HISTORIC AND DESIGN REVIEW COMMISSION

HDRC CASE NO:	2023-360
ADDRESS:	915 MASON ST
LEGAL DESCRIPTION:	NCB 1267 BLK 3 LOT S 105 FT OF 7
ZONING:	R-6, H
CITY COUNCIL DIST.:	2
DISTRICT:	Government Hill Historic District
APPLICANT:	Michael Krause/Mychals Designs LLC
OWNER:	Sevda Johnson/SEVHAS INVESTMENTS LLC
TYPE OF WORK:	Construction of a rear addition, door replacement, fenestration modifications, and porch modifications
APPLICATION RECEIVED:	November 02, 2023
60-DAY REVIEW:	January 01, 2024
CASE MANAGER:	Jessica Anderson
REQUEST:

The applicant requests a Certificate of Appropriateness for approval to:

2 1ST. FLOOR PROPOSED
1/4" = 1'-0"

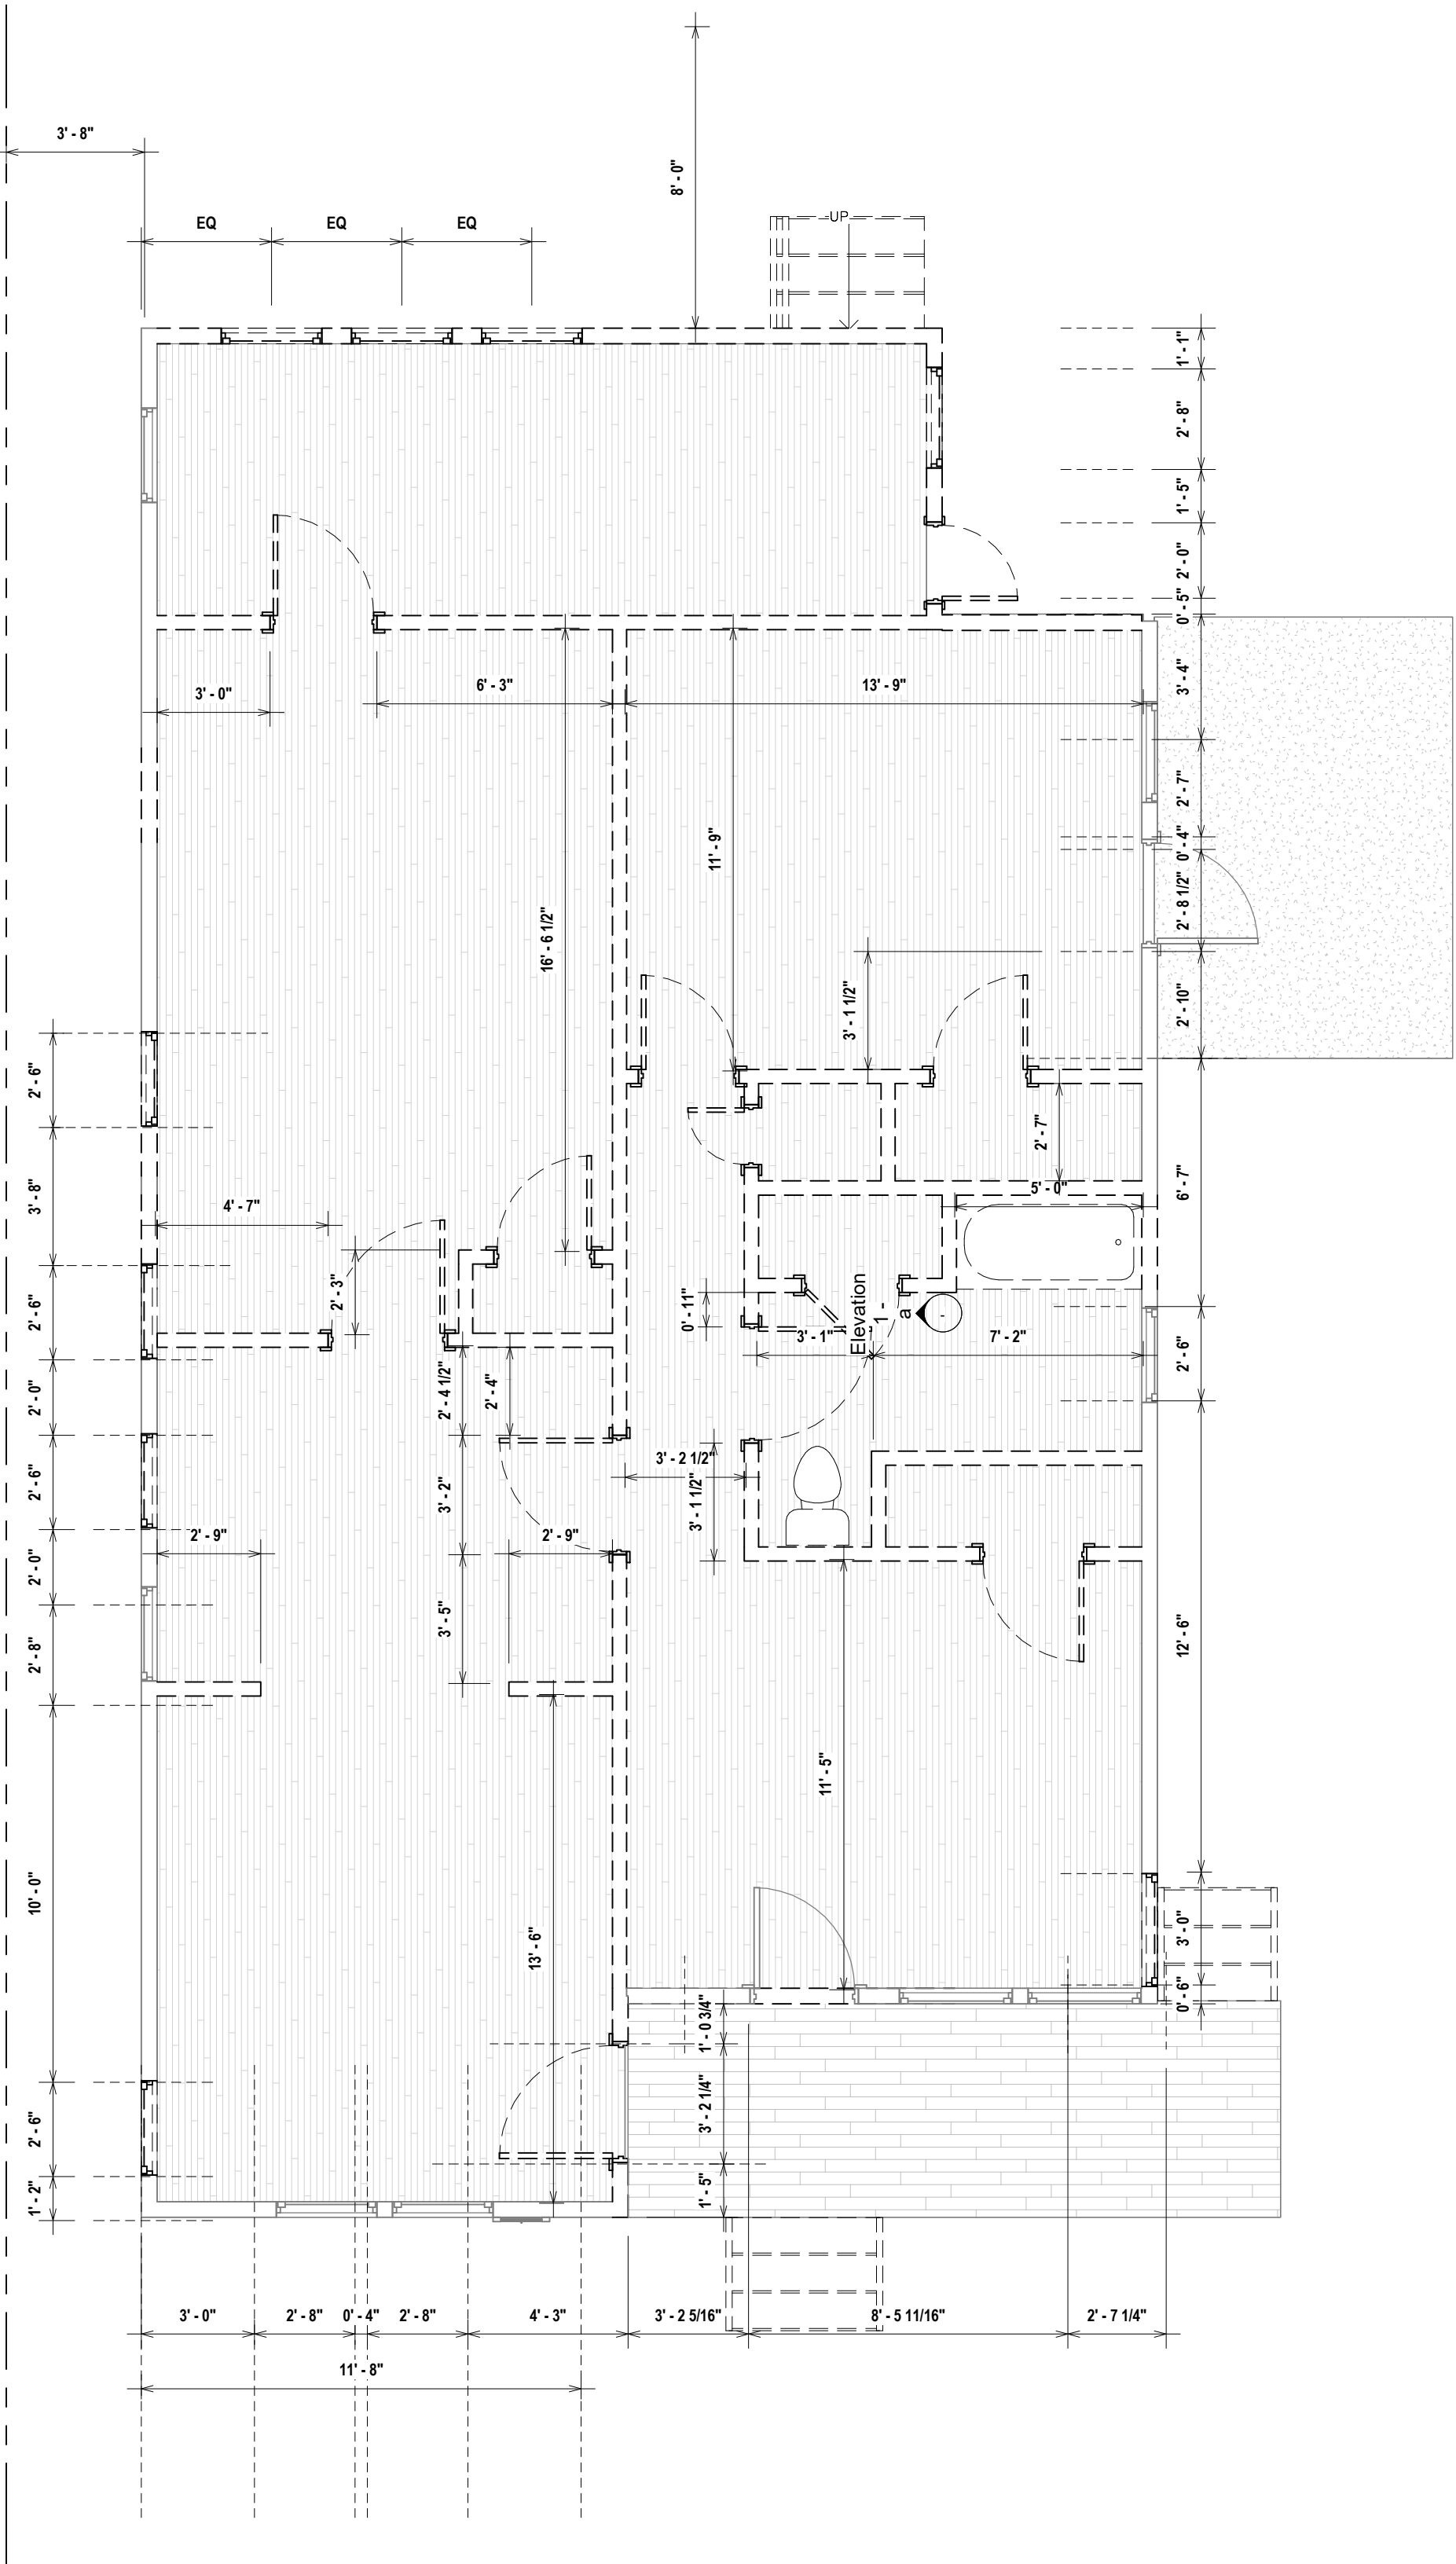
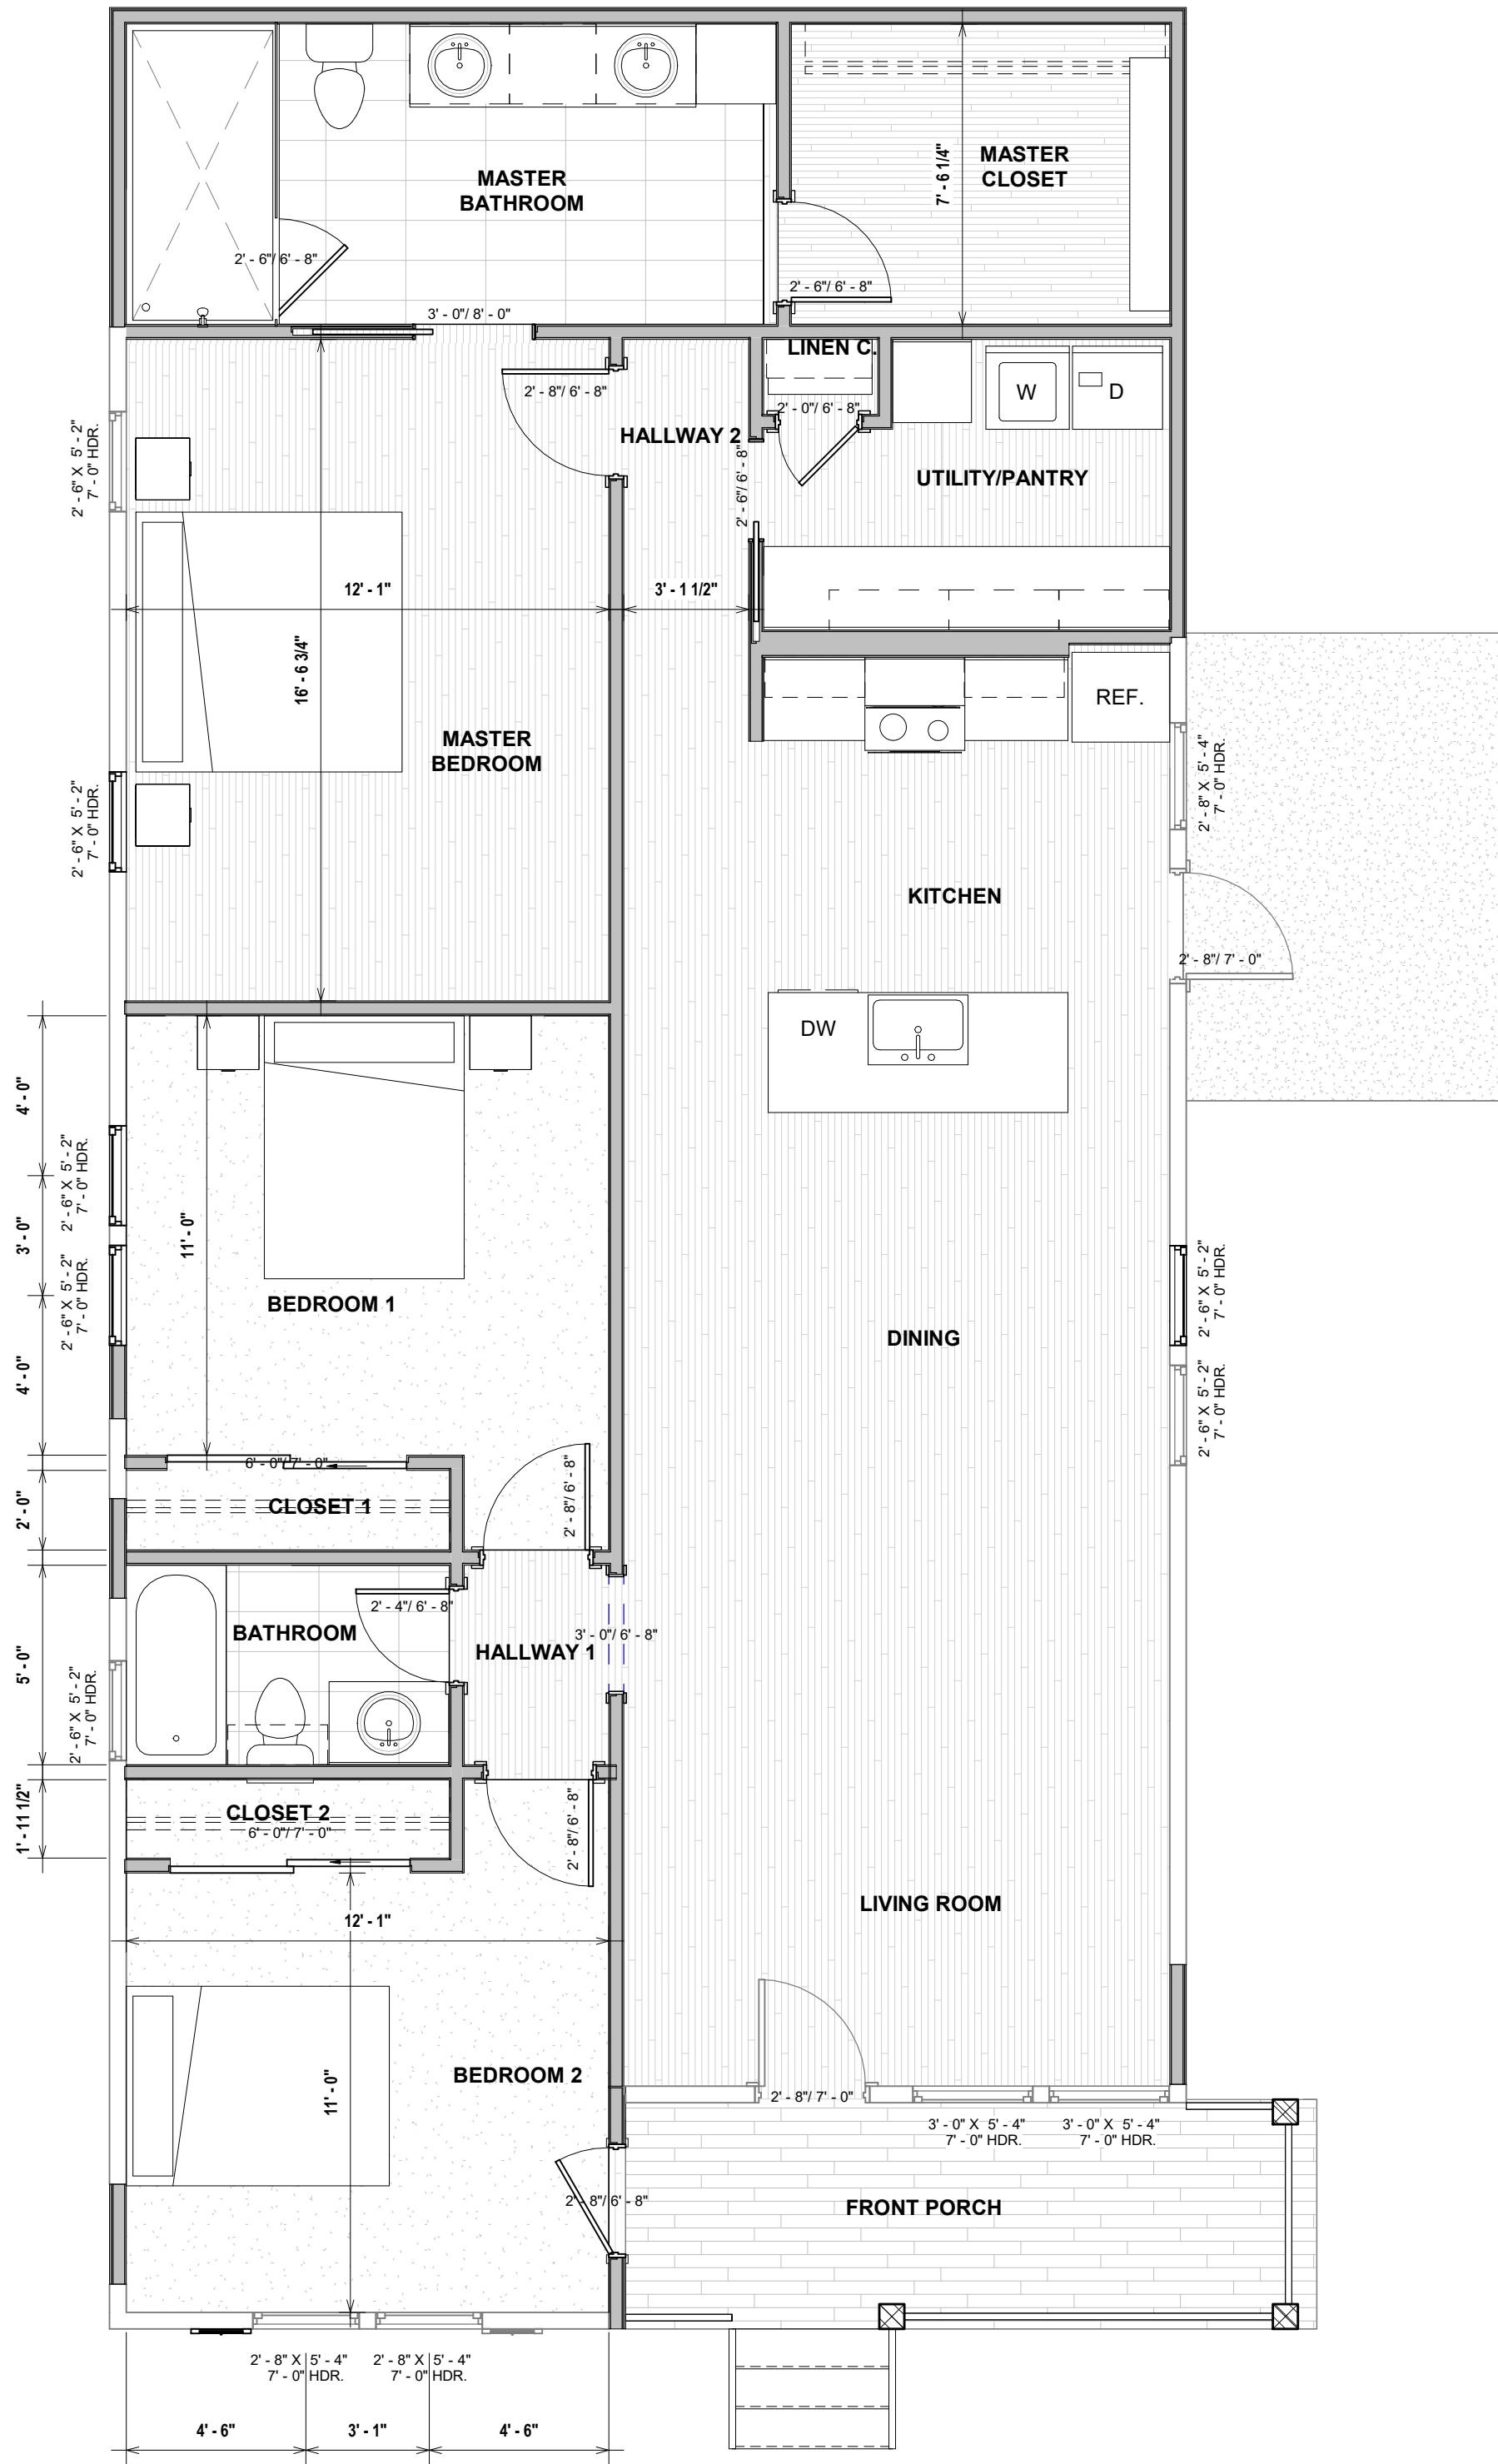
- d. **ADDITION:** The applicant requests to construct a rear addition. The plans submitted for review are not fully dimensioned. Historic Design Guidelines for Additions 1.A.i says to site residential additions at the side or rear of the building whenever possible to minimize views of the addition from the public right-of-way. Guideline 1.A.iv says utilize a setback or recessed area and a small change in detailing at the seam of the historic structure and new addition to provide a clear visual distinction between old and new building forms. Staff finds the rear addition generally appropriate, but that additional fenestration be added to the north elevation and a visual break between old and new should be introduced to the plan. Any windows included on the new addition should conform to Standard Specifications for Windows in Additions and New Construction, including but that they are the same dimensions and proportions as existing windows and feature a meeting rail no taller than 1.25", stiles no wider than 2.25", top and bottom sashes of equal size, and a minimum depth of 2" between the front face of the window trim and the front face of the top window sash.

- g. **WINDOWS:** The applicant proposes to infill, modify, and add windows on the east and west elevations of the existing house. Historic Design Guidelines for Exterior Maintenance and Alterations 6.A.i says to preserve existing window and door openings. Avoid enlarging or diminishing to fit stock sizes or air conditioning units. Avoid filling in historic door or window openings. Avoid creating new primary entrances or window openings on the primary façade or where visible from the public right-of-way. Staff finds that the request to infill, modify, and add windows to the existing house does not conform to guidelines. All existing windows on the house be retained and repaired, except where they are removed on the north elevation for the proposed addition.

- h. **WINDOWS (CONSTRUCTION DRAWINGS):** The drawings submitted by the applicant show conditions that are not part of the request, namely the inclusion of awning windows on the east and west elevations. Should the HDRC find infill, modification, and/or addition of windows on the existing house appropriate, the applicant must submit accurate measured drawings, an annotated window schedule, interior and exterior photos of windows requested for replacement, and complete manufacturer's specifications and a cut sheet for the proposed new window product.

- i. That the applicant submits full measured drawings for the addition for staff review.
- ii. That the applicant proposes additional fenestration on the north elevation, as noted in finding d.

- iii. That the applicant installs a fully wood window product that meets staff's standard window stipulations and submits updated specifications to staff for review and approval. The windows should feature an inset of two (2) inches within facades and should feature profiles that are found historically within the immediate vicinity. Meeting rails must be no taller than 1.25" and stiles no wider than 2.25". White manufacturer's color is not allowed, and color selection must be presented to staff. There should be a minimum of two inches in depth between the front face of the window trim and the front face of the top window sash. This must be accomplished by recessing the window sufficiently within the opening or with the installation of additional window trim to add thickness. Window trim must feature traditional dimensions and architecturally appropriate sill detail. Window track components must be painted to match the window trim or concealed by a wood window screen set within the opening.

Staff does not recommend approval of item 4, infilling, modifying, and adding windows on the east and west elevations, based on findings g and h.
